<b>Docket Number:</b>	16-AFC-01C
<b>Project Title:</b>	Stanton Energy Reliability Center - Compliance
<b>TN #:</b>	232811
<b>Document Title:</b>	Stanton Energy Reliability Center - Compliance
<b>Description:</b>	The project owner proposes to use an additional 0.71-acre offsite for the use of temporary construction laydown and staging, parking, and temporary offices.
<b>Filer:</b>	John Heiser
<b>Organization:</b>	California Energy Commission
<b>Submitter Role:</b>	Commission Staff
<b>Submission Date:</b>	4/22/2020 7:21:48 AM
<b>Docketed Date:</b>	4/22/2020

## **STATEMENT OF STAFF APPROVAL OF POST CERTIFICATION CHANGE STANTON ENERGY RELIABILITY CENTER (16-AFC-01C)**

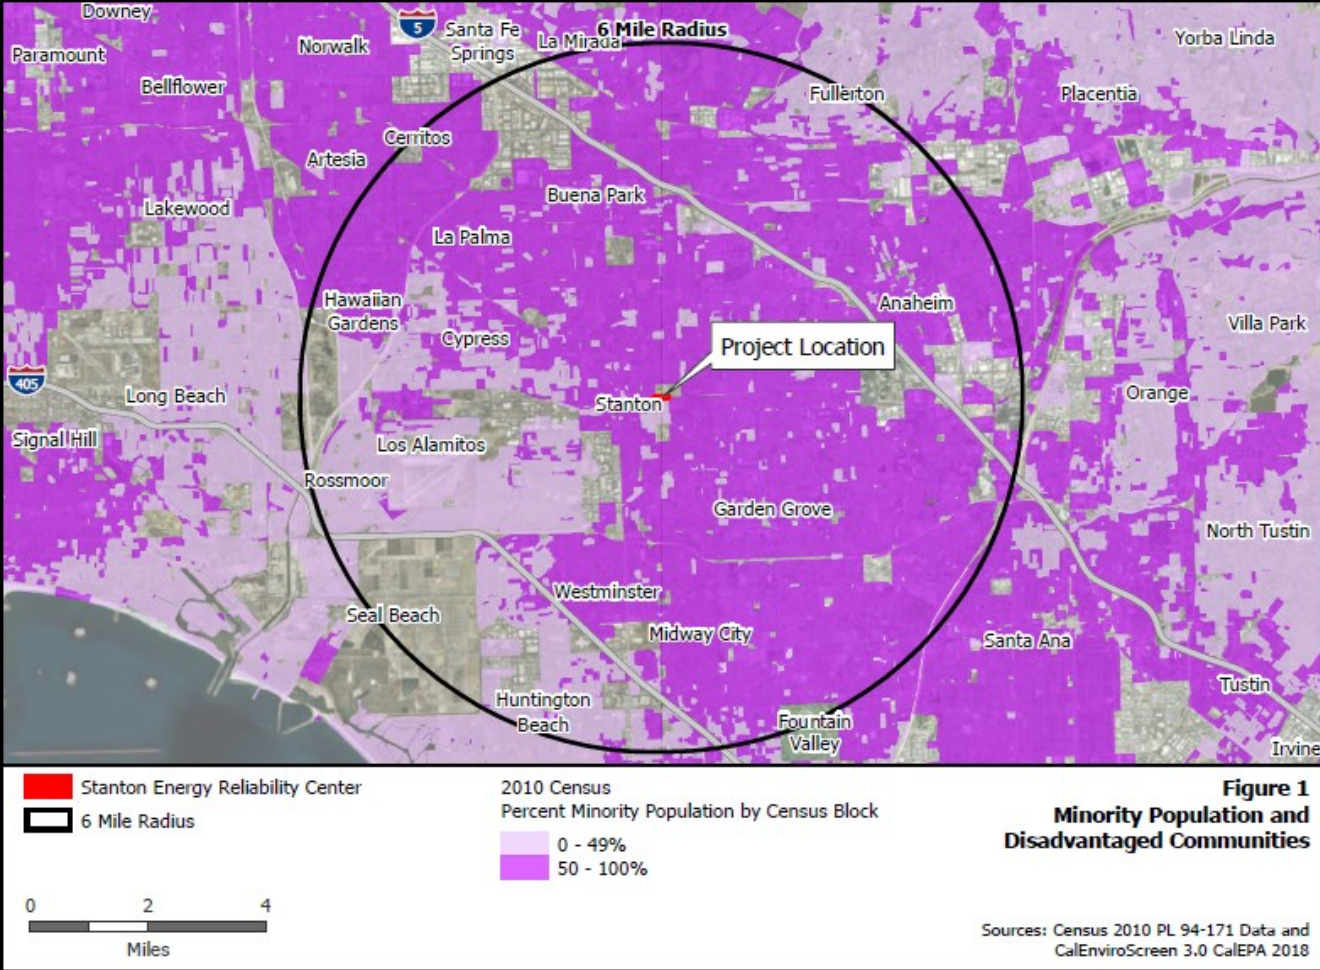
**Environmental Justice Figure 1** shows 2010 census blocks in the six-mile radius of the SERC project site with a minority population greater than or equal to 50 percent. The population in these census blocks represents an environmental justice (EJ) population based on race and ethnicity as defined in the United States Environmental Protection Agency's *Guidance on Considering Environmental Justice During the Development of Regulatory Actions*. Staff conservatively obtains demographic data within a six-mile radius around a project site based on the parameters for dispersion modeling used in staff's air quality analysis. Air quality impacts are generally the type of project impacts that extend the furthest from a project site. Beyond a six-mile radius, air emissions have either settled out of the air column or mixed with surrounding air to the extent the potential impacts are less than significant. The area of potential impacts would not extend this far from the project site for most other technical areas included in staff's EJ analysis.

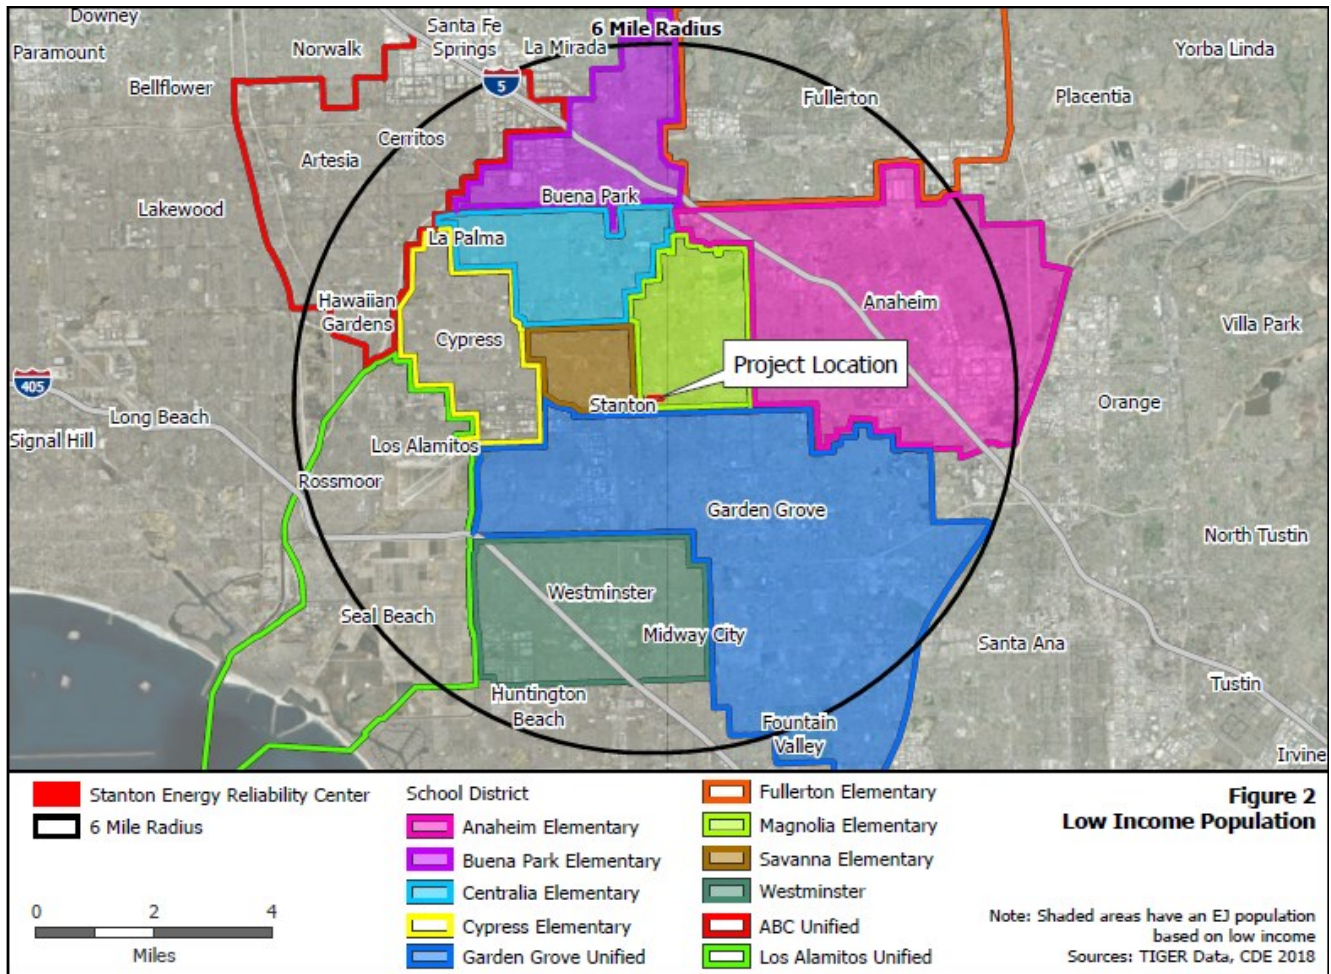
Based on California Department of Education and American Community Survey data in the **Environmental Justice Table 1**, staff concluded that the percentage of those living in the Westminster, Centralia Elementary, Buena Park Elementary, Magnolia Elementary, Savanna Elementary, Garden Grove Elementary, and Anaheim Elementary school districts (in a six-mile radius of the project site) and enrolled in the free or reduced price meal program is larger than those in the reference geography, and thus are considered an EJ population based on low income as defined in *Guidance on Considering Environmental Justice During the Development of Regulatory Actions*. **Environmental Justice Figure 2** shows where the boundaries of the school districts and cities are in relation to the six-mile radius around the SERC site.
